Addendum #3
Historic Oak View County Park Renovations

To: All Plan Holders
 From: Kimley-Horn & Associates
 Date: Friday, February 6, 2026
 Project Name: Historic Oak View County Park Renovation
 Project: RFB #26-001
 Subject: Addendum #3

SHEET NUMBER
C4.1

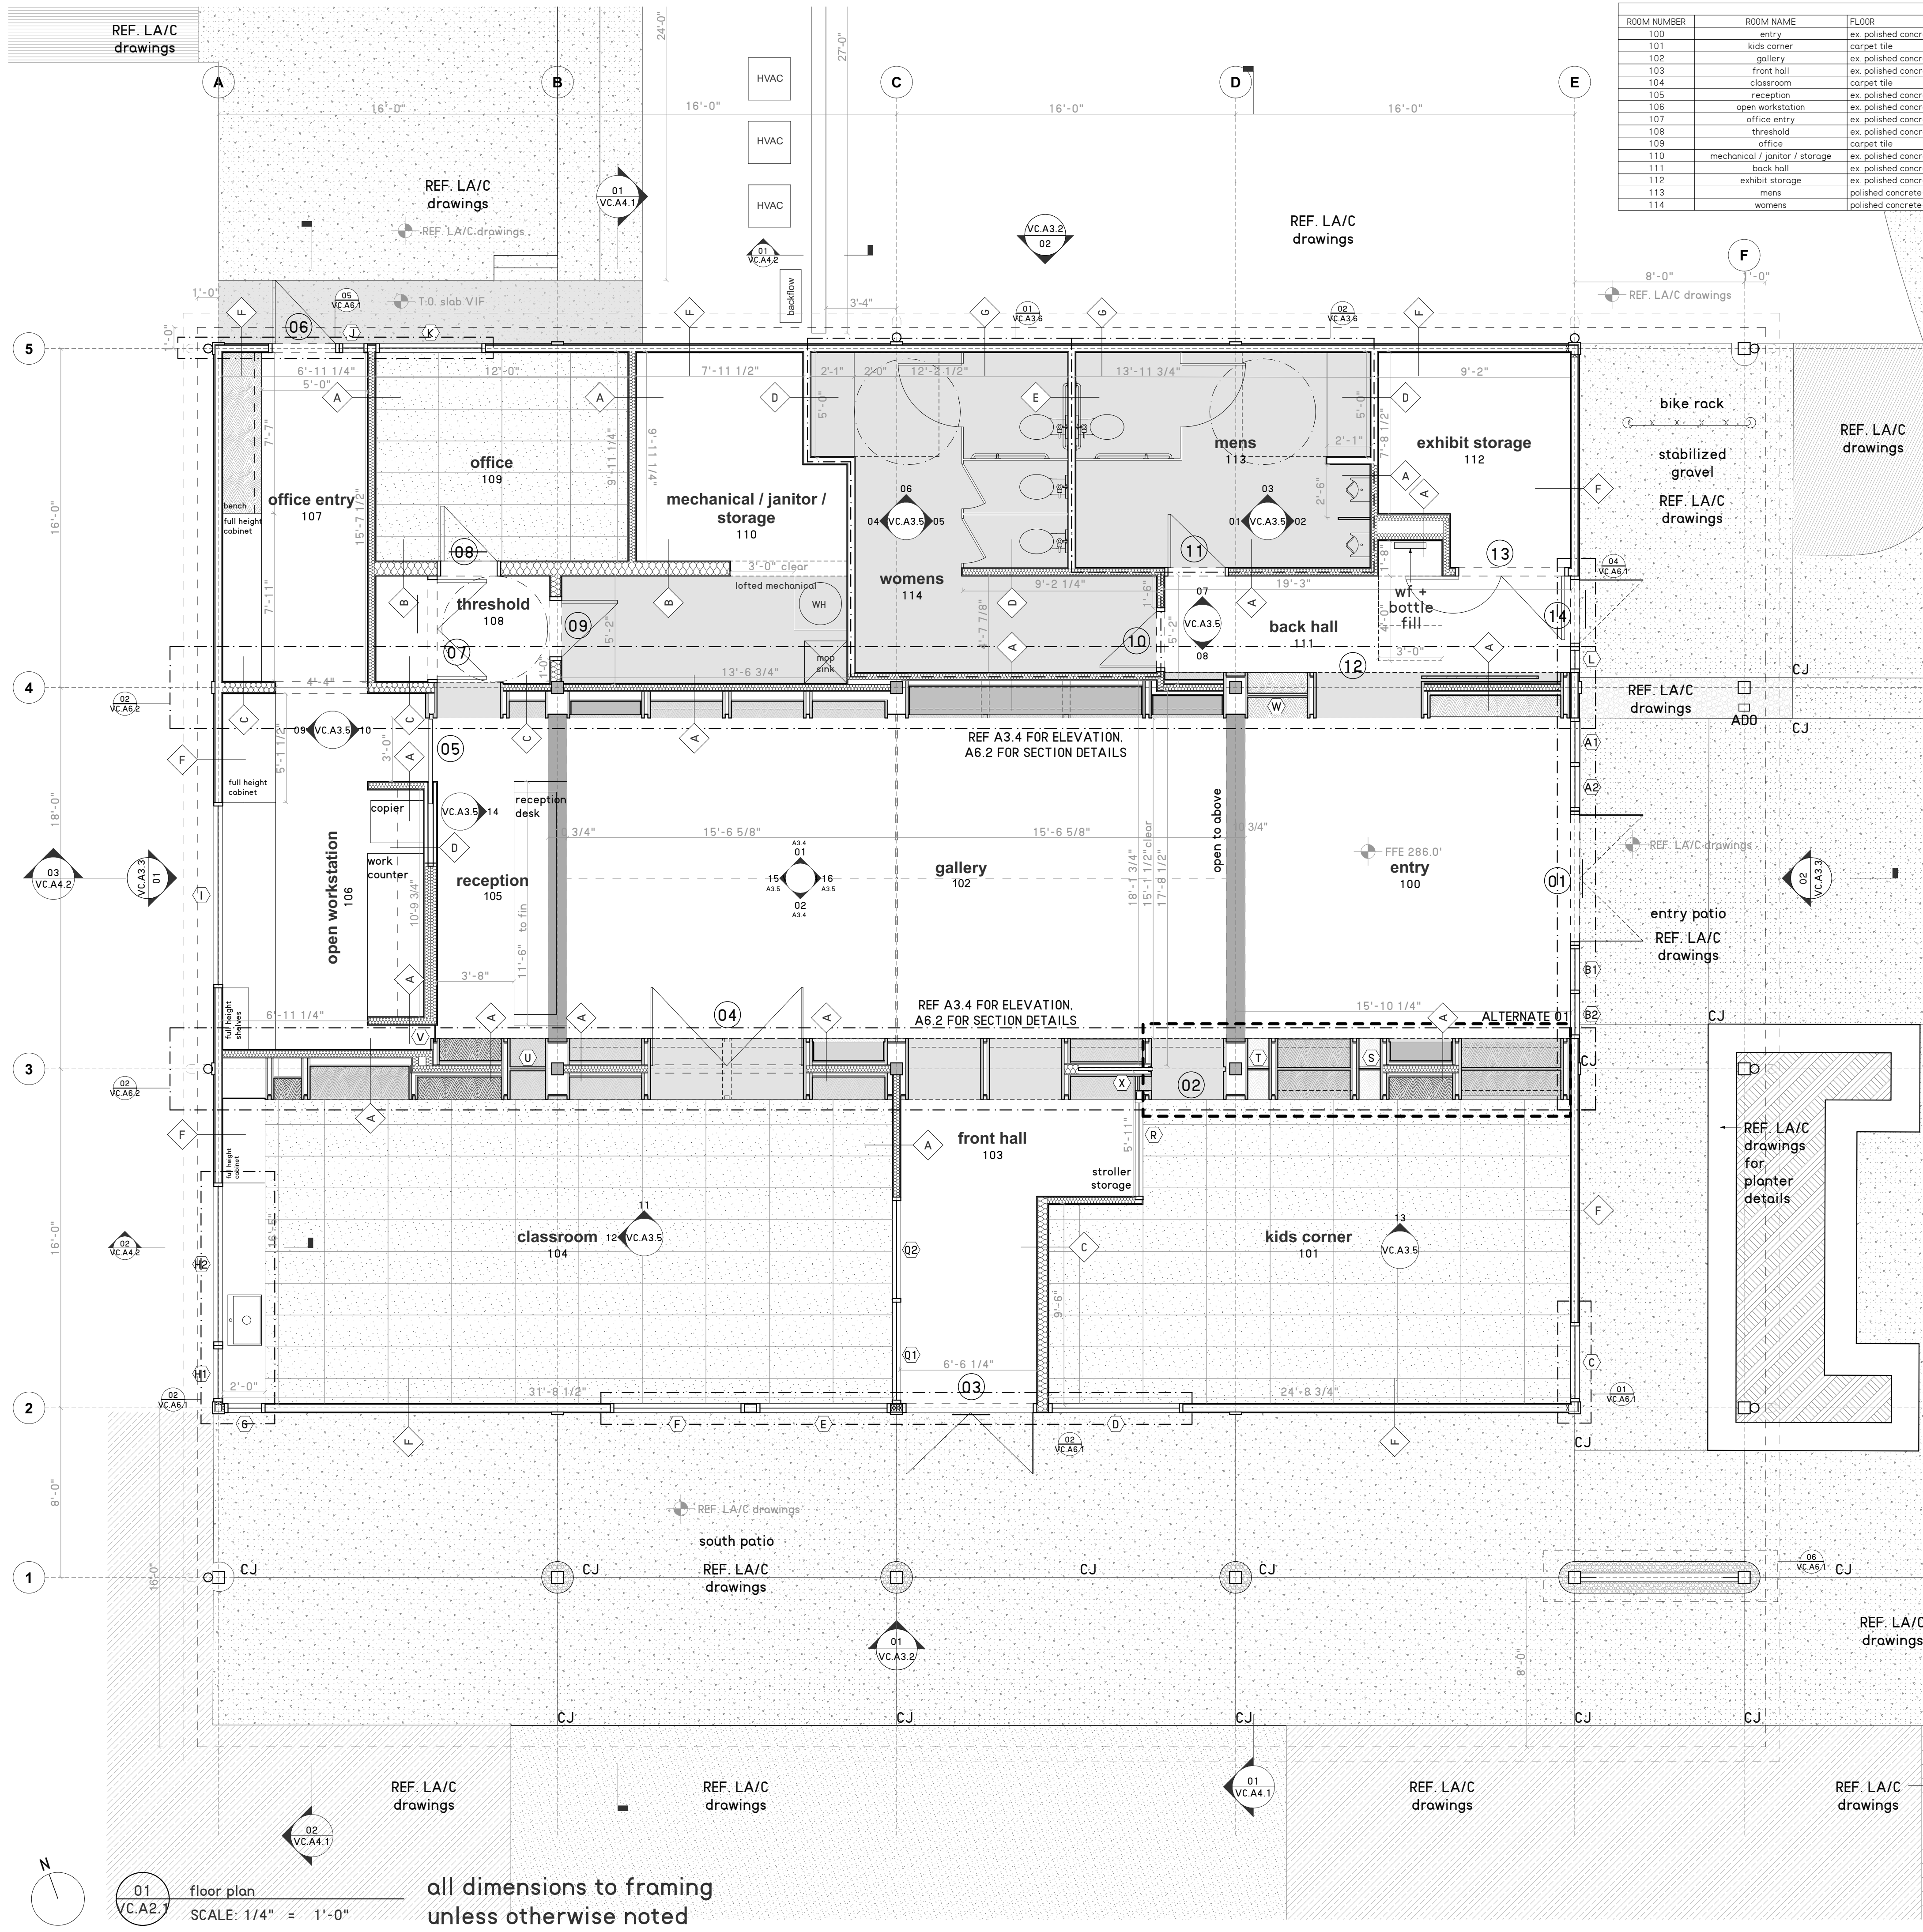
21. **Q:** How is the new outdoor water fountain at the Bluebird Shelter getting water?
A: Sheet 2.2 – Demolition Plan Enlargement and Sheet C4.1 – Fire Access and Hose Lay Plan have both been updated to reflect utility service to the proposed drinking fountain at the Bluebird Shelter. Please see Sheet C2.2 and C4.1 included as attachments to this Addendum for updated utility service to the drinking fountain.
